**1. COA-054468-2019**

2308 East Marshall Street

## STAFF REPORT

**Replace front door and convert a rear second-story window into a door.**

Figure 1. 1952 Sanborn Map

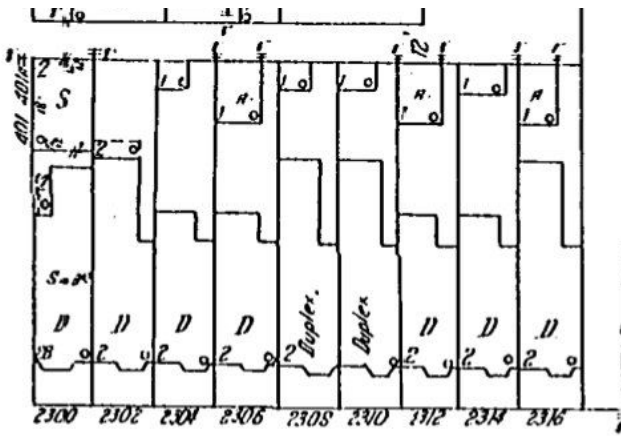
The applicant is proposing to convert a rear second-story door to a window. Sanborn maps do not show a porch or stairway at the rear of the structure; however, they do indicate that the single-family residence was converted to a duplex between 1925 and 1950. At this time a second egress could have been added to the second story. The opening also shows evidence of being altered as the arched lintel aligns with other windows on the second story. As the applicant is proposing to remove a likely later alteration and reconstruct the historic configuration, staff recommends approval of the installation of a window in the opening.

Physical and documentary evidence appear to indicate that the rear stair was added when the building was converted to a duplex. As the rear porch has not achieved significance and is not a contributing part of the historic character of the building, staff recommends approval of the demolition of the rear stair.
